# UNITED STATES PATENT AND TRADEMARK OFFICE

APPLICATION NO.	FILING DATE	FIRST NAMED INVENTOR	ATTORNEY DOCKET NO.	CONFIRMATION NO.
10/608,671	06/27/2003	Michael J. Puglia	017191.0033 (MSA-3452)	5201

<b>Office Action Summary</b>	<b>Application No.</b> 10/608,671	<b>Applicant(s)</b> PUGIA ET AL.	
	<b>Examiner</b> Brian J. Sines	<b>Art Unit</b> 1797

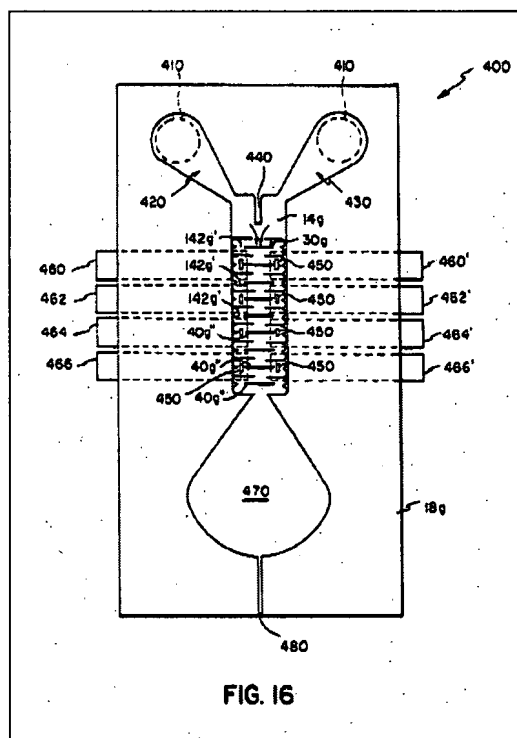
Regarding claim 9, claim 1 of the copending application does not recite the incorporation of an overflow chamber.

Columbus '476 teaches the incorporation of an overflow chamber 470 within a microfluidic device to facilitate effective sample fluid introduction and subsequent processing (see figure 16). Therefore, it would have been obvious to a person of ordinary skill in the art to incorporate an overflow chamber within the disclosed microfluidic device to facilitate effective sample fluid introduction and subsequent processing.

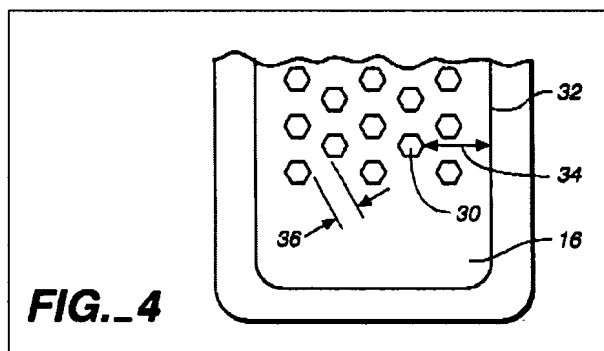
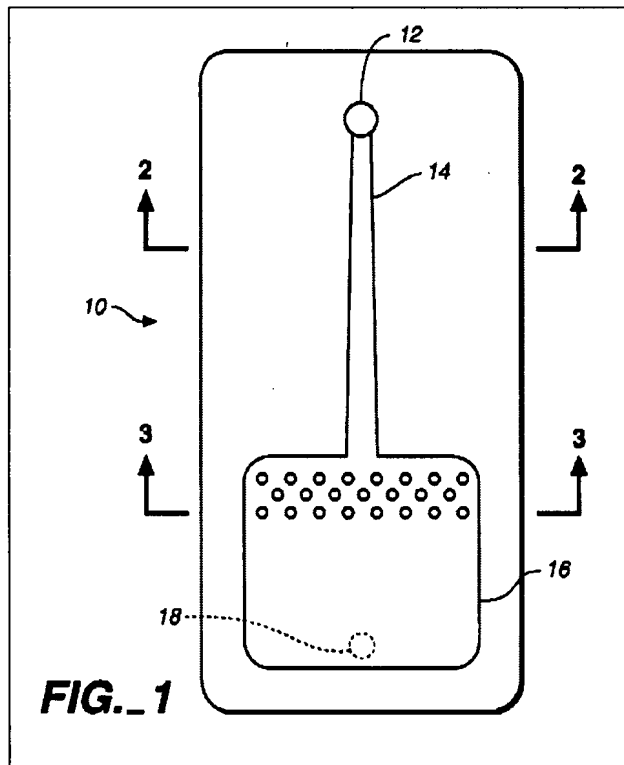
Regarding claim 1, Beuchler teaches a microfluidic device comprising: an inlet port 12; an enclosed capillary passageway 14 in fluid communication with the inlet port 12; an enclosed inlet chamber (e.g., distal region 16) comprising an array of post structures (i.e., capillarity-

inducing structures 30); and a vent structure (i.e., escape port 18) (see col. 5, line 21 – col. 7, line 43; figures 1 & 4). As shown in figure 1, the enclosed inlet chamber 16 is in fluid communication at one side or end side thereof with the enclosed capillary passageway 14. In addition, as shown in figure 1, the vent passageway 18 is positioned at a top side of the enclosed inlet chamber opposite the entry of the capillary passageway 14 into the enclosed inlet chamber 16.

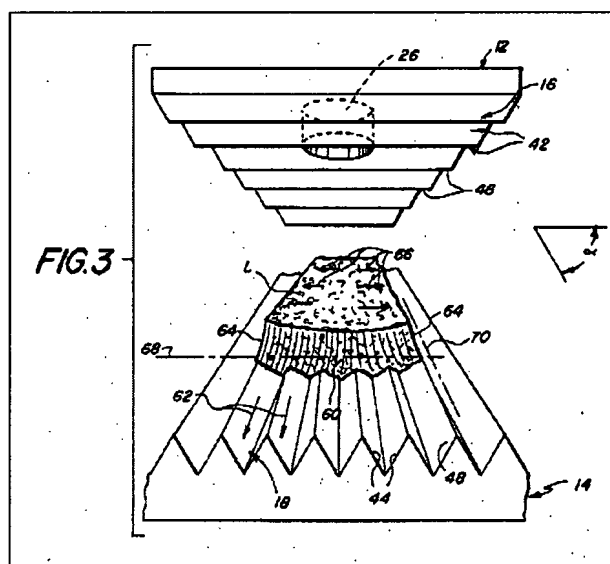
In this regard, Columbus teaches the use of groove structures (e.g., 42 & 44) for facilitating uniform fluid flow within microfluidic devices (see, e.g., col. 5, lines 1 – 55; figure 3). Columbus shows an entry aperture 26 leading to chamber structure underneath defined by surfaces 16 and 18, wherein grooves 42 and 44 extend across the top surfaces of this chamber (see figure 3).

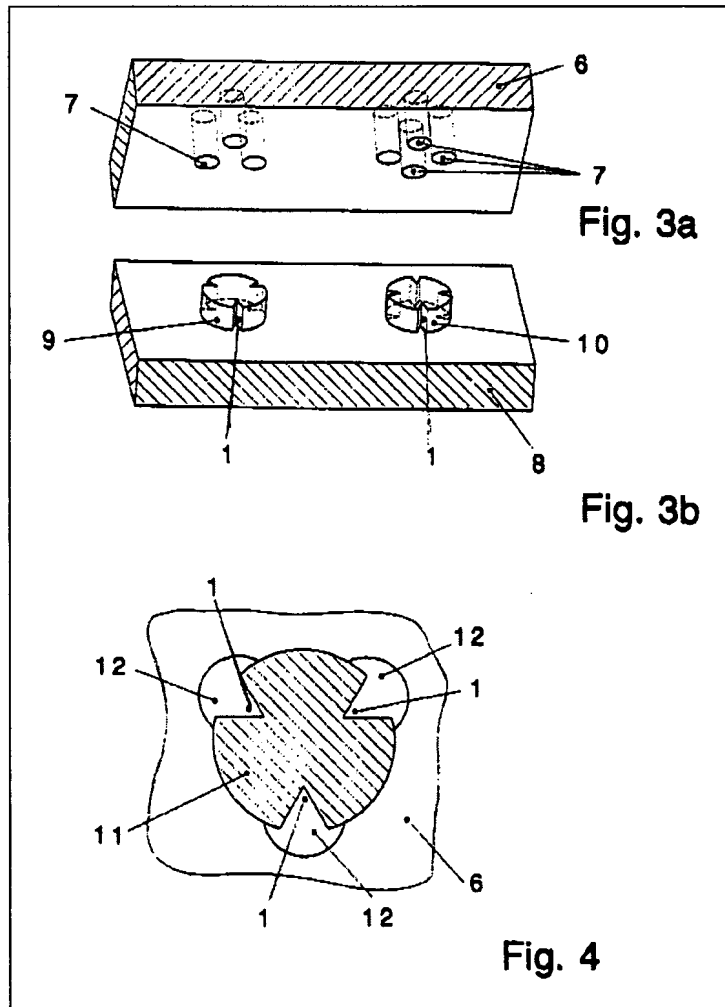
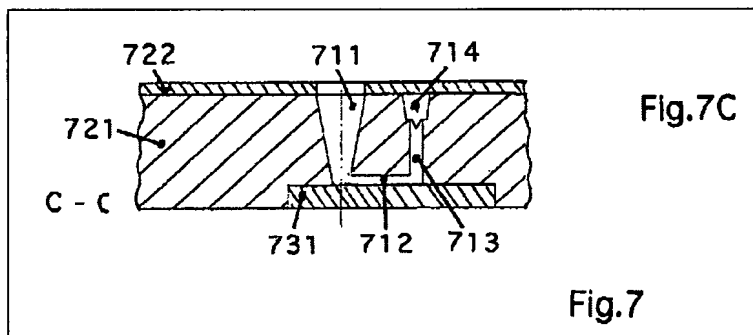
Regarding claims 4 and 6, Buechler and Columbus are silent to the specific teaching of incorporating wedge-shaped cut-out structures with either a groove or weir structure configuration as claimed within the disclosed microfluidic device. As shown in figure 3b, Peters does teach the incorporation of wedge-shaped cut-out structures (post or columnar projection 9 having wedge-shaped cut-outs 1) within a microfluidic apparatus for facilitating effective fluid control within a microfluidic device (see col. 1, line 10 – col. 6, line 67; figures 1a, 3b & 4).

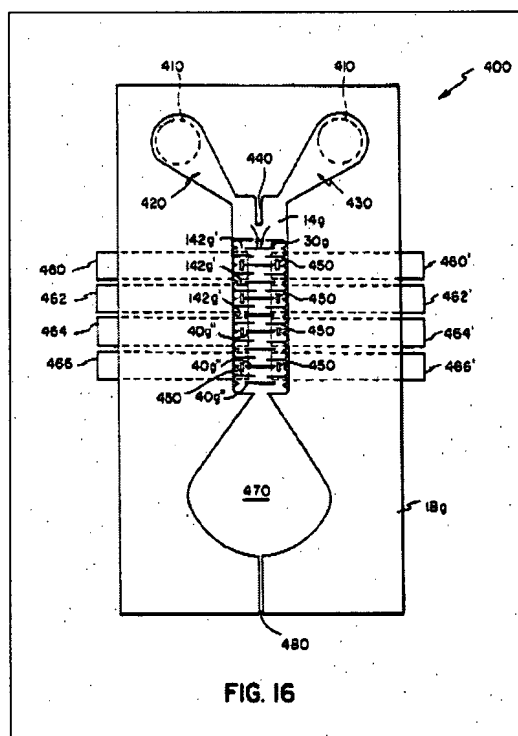
Regarding claim 9, Beuchler and Columbus do not specifically teach the incorporation of an overflow chamber.

Columbus '476 teaches the incorporation of an overflow chamber 470 within a microfluidic device to facilitate effective sample fluid introduction and subsequent processing (see figure 16). Therefore, it would have been obvious to a person of ordinary skill in the art to incorporate an overflow chamber within the disclosed microfluidic device to facilitate effective sample fluid introduction and subsequent processing.
